Owner Change Order

Change Order Number: 003

City of Norman - North Base Complex Phase 1
1310-1380 DA Vinci Street
Norman, Oklahoma 73069

The Contract is hereby revised by the following items:

DRAWING NO.
E3-01

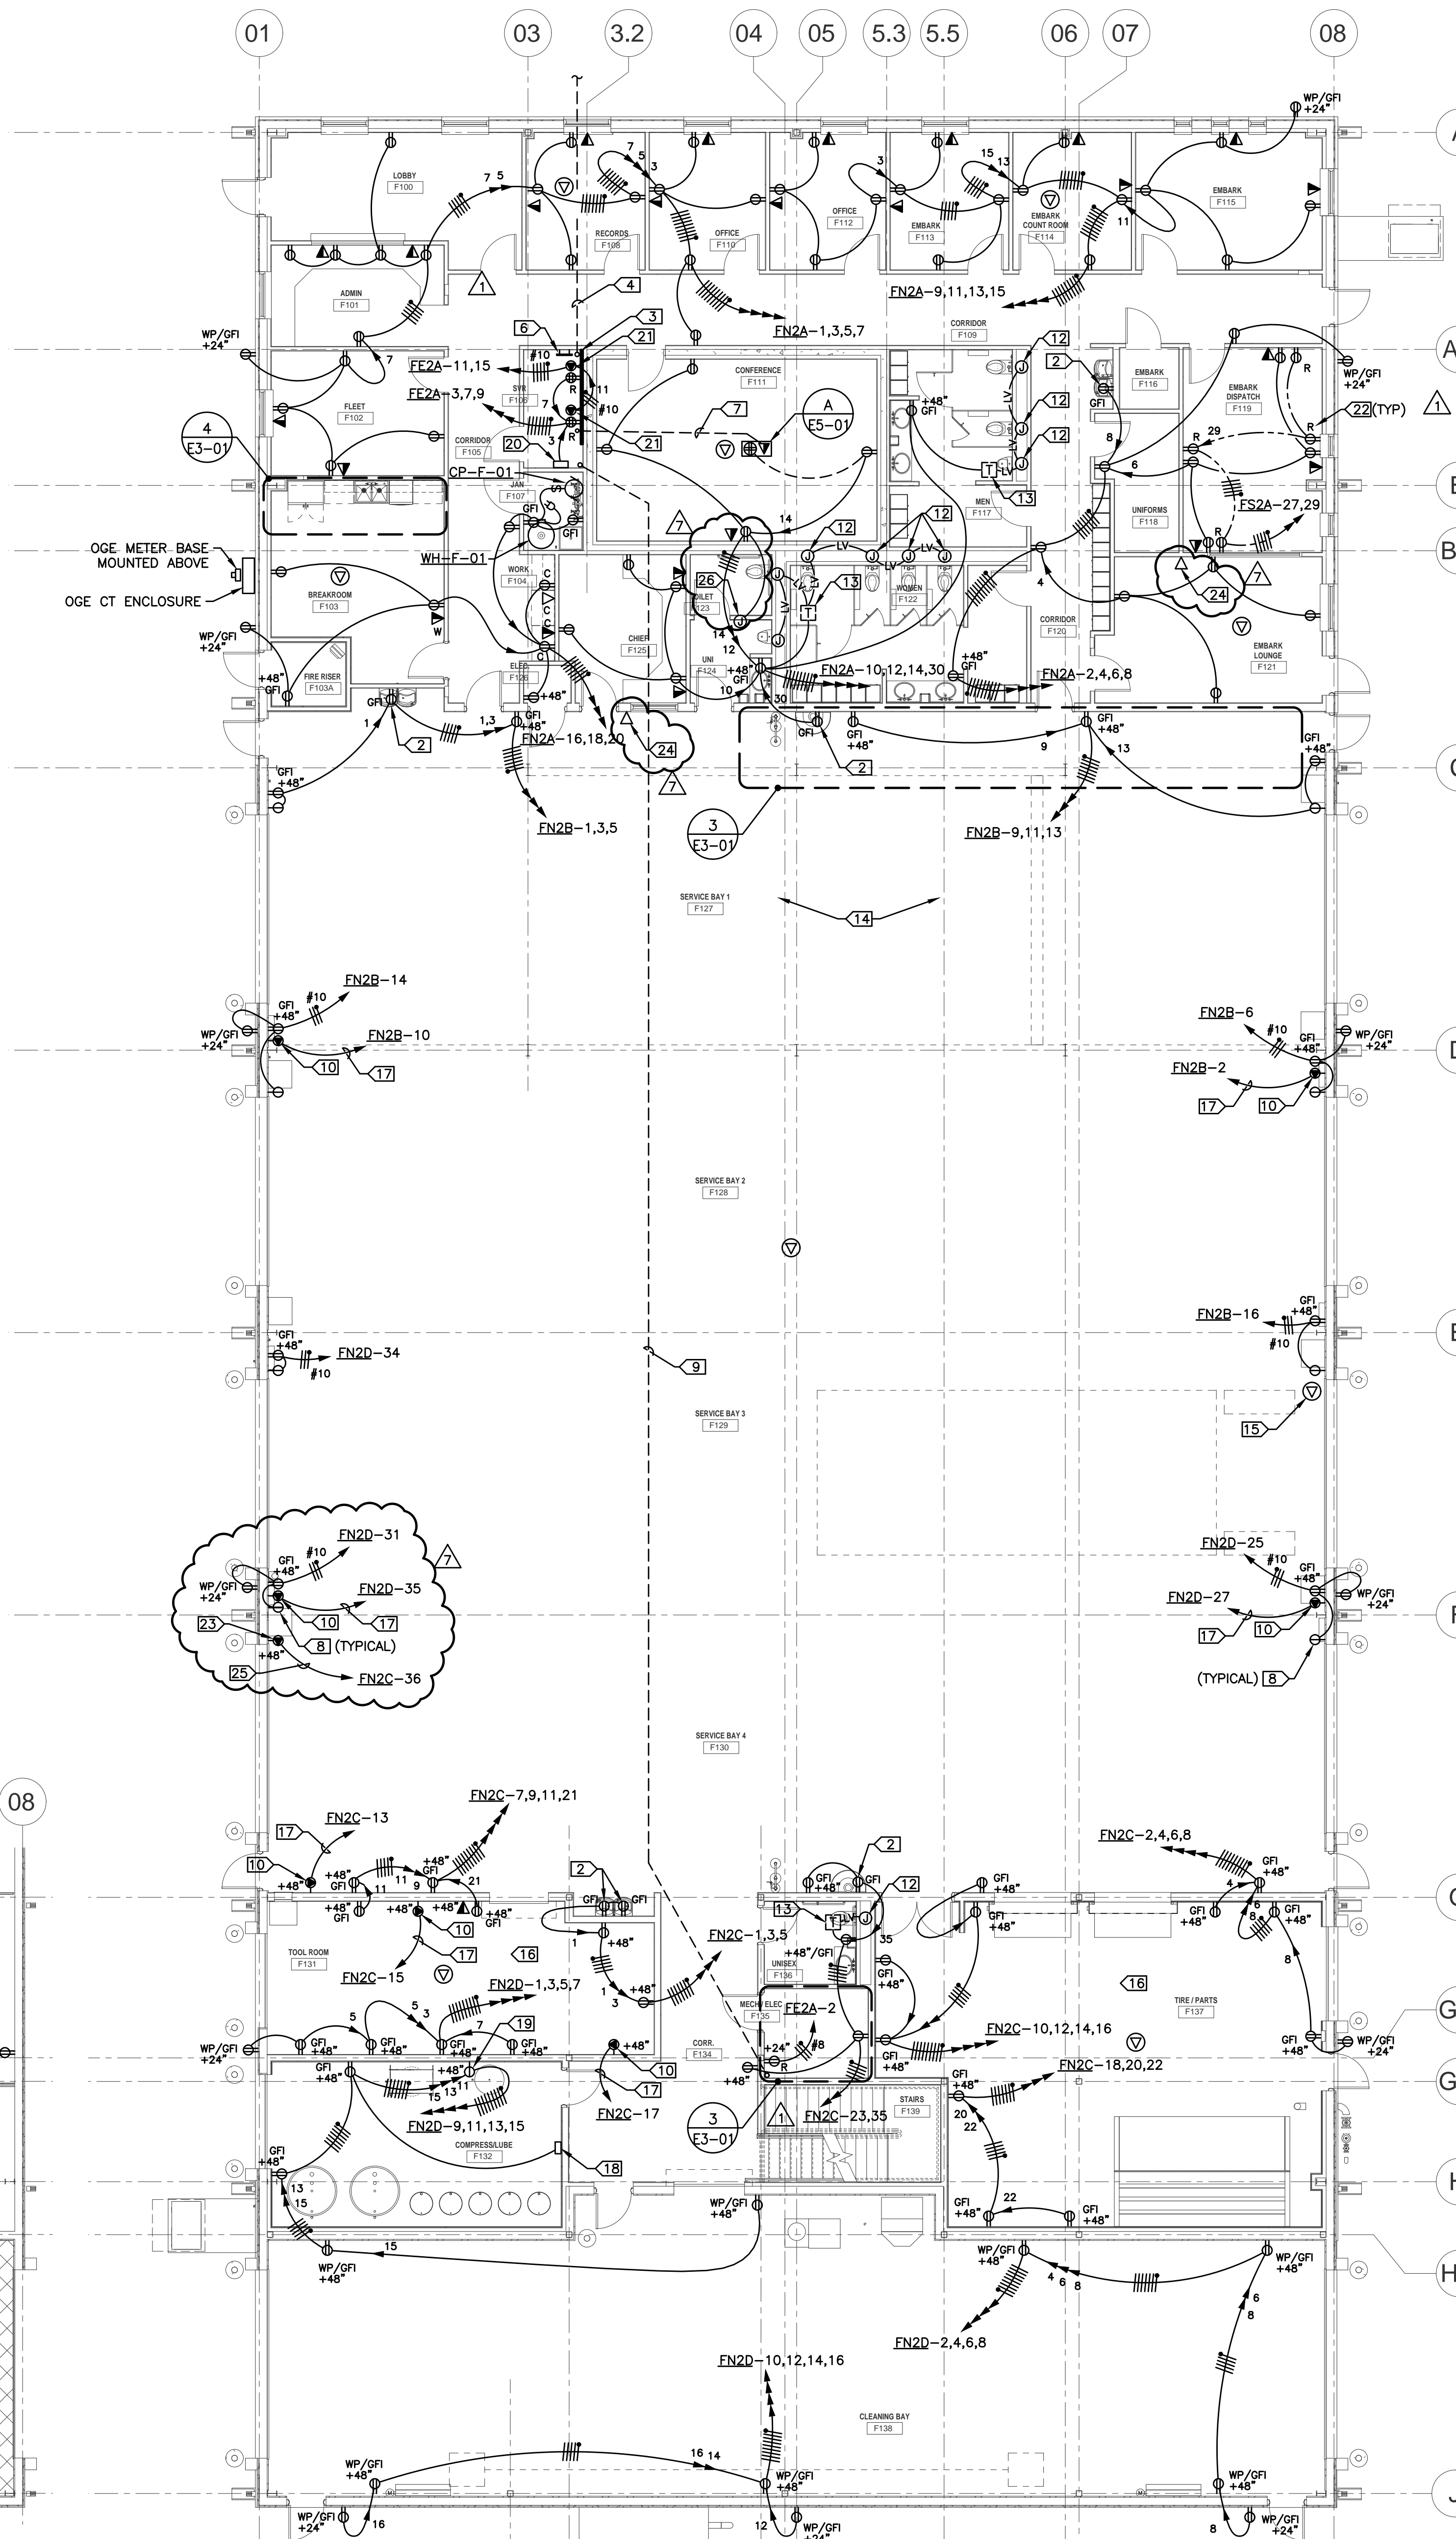
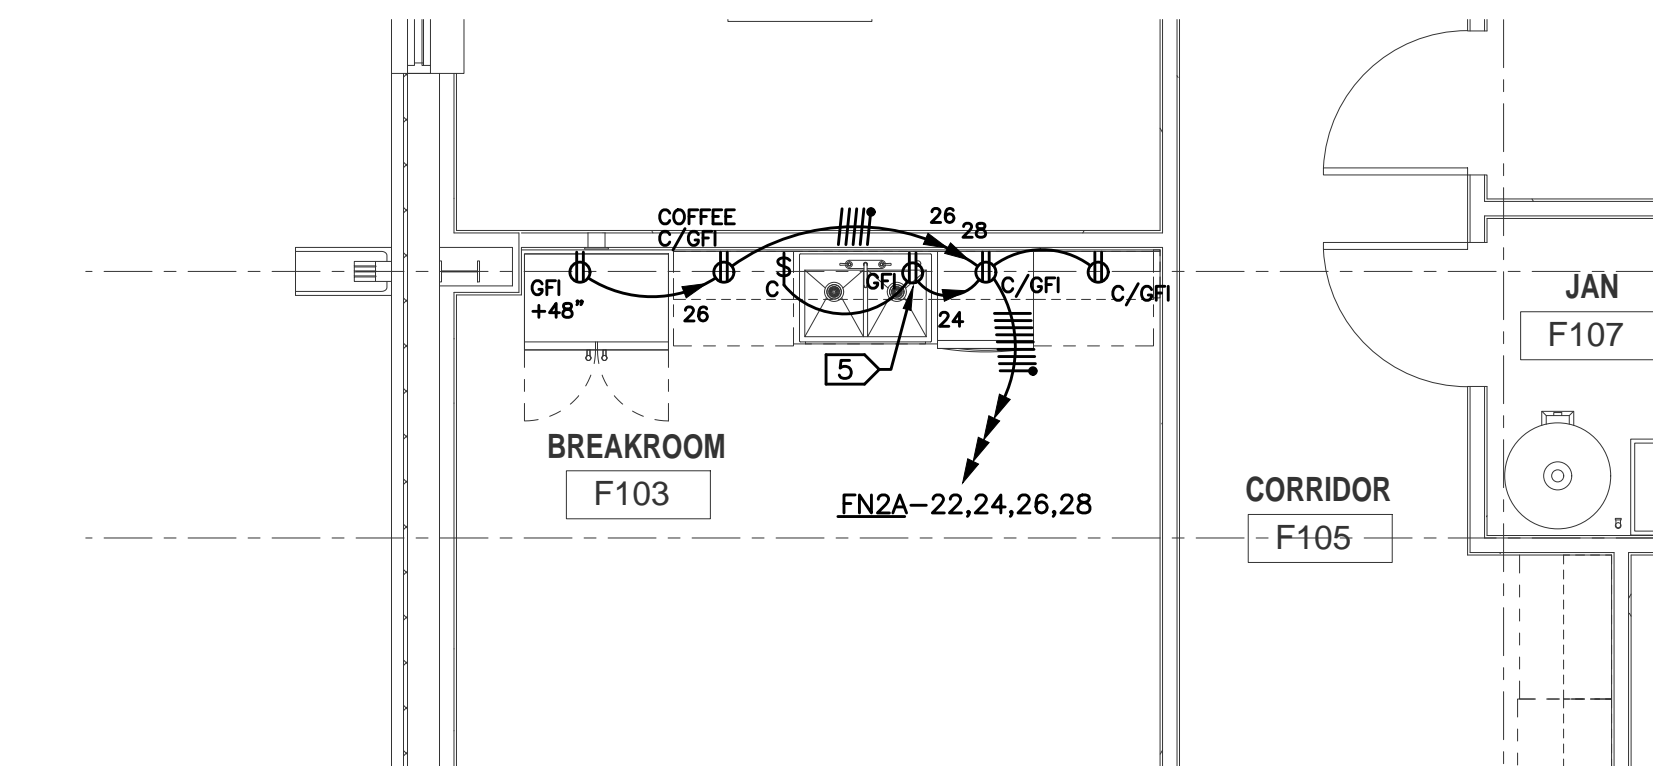
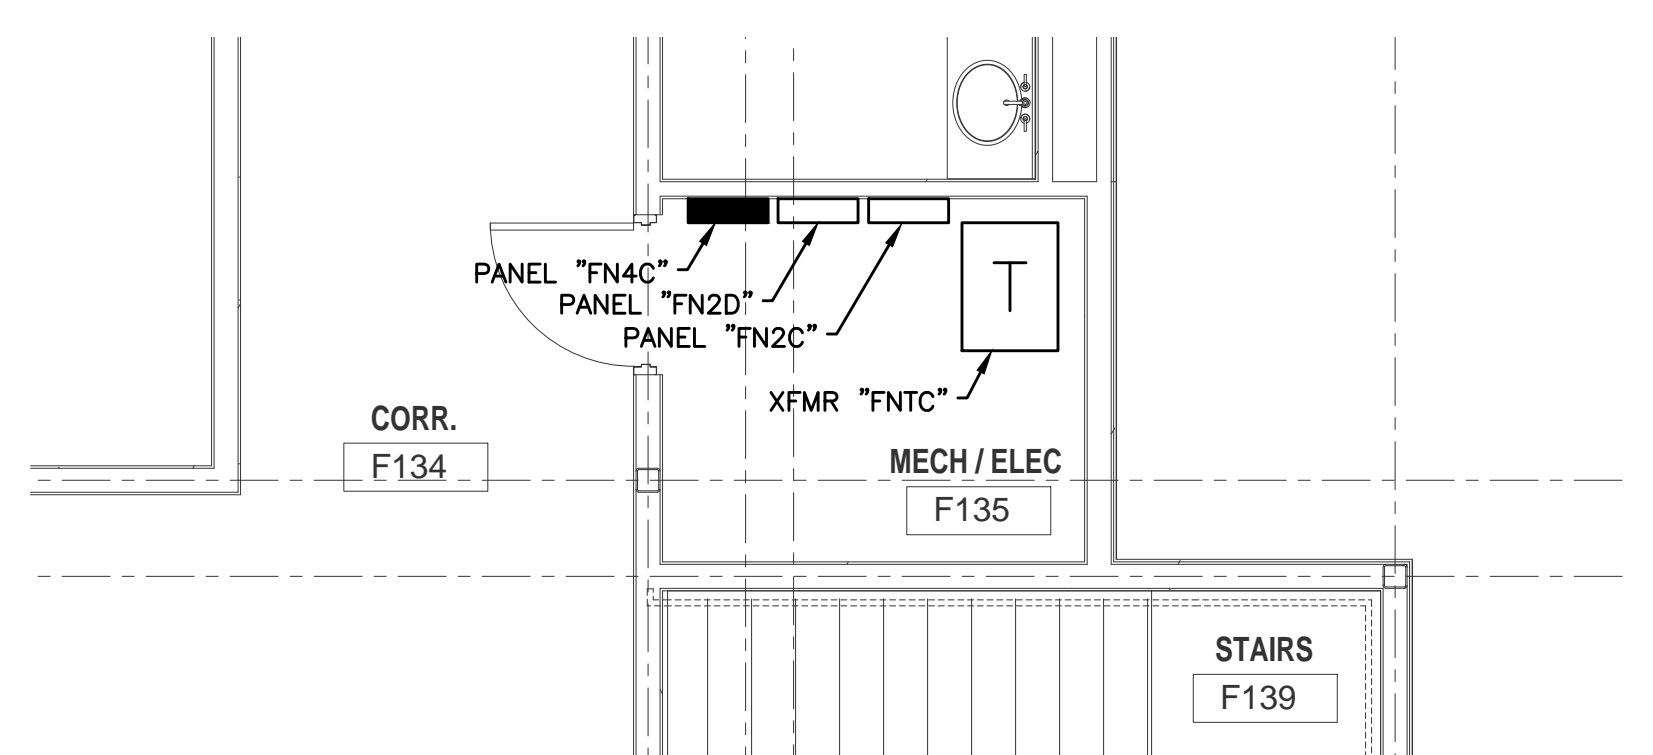
Item	Qty	Unit	Description	Labor Hours	Ext	Material	Ext	Open	Ext
1			added 2 data roughs, circuit for forklift, and						
2			circuit for drug test controller						
3									
4	2	e	10' sticks of 3/4" emt for data rough			12.50	25.00		
5	2	e	4sqr for data rough			5.00	10.00		
6	2	e	2 hours 1 man labor	1	2.00				
7									
8	13	e	10' sticks of 3/4" emt for fork lift			12.50	162.50		
9	1	e	3/4" seal off			25.00	25.00		
10	390	e	130 x 3 of #12 thhn			0.25	97.50		
11	6	e	6 hours labor	1	6.00				
12									
13	1.5	e	10' stick of 3/4" emt for drug test station			12.50	18.75		
14	2	e	4sqr boxes			5.00	10.00		
15	60	e	20' x 3 of #12 thhn			0.25	15.00		
16	3	e	3 hours 1 man labor	1	3.00				
17									
18									
19									
20									
21									
22									
23									
24									
25									
26									
27									
28									
29									
30									
31									
32									
Totals				3	11.00		363.75		0.00
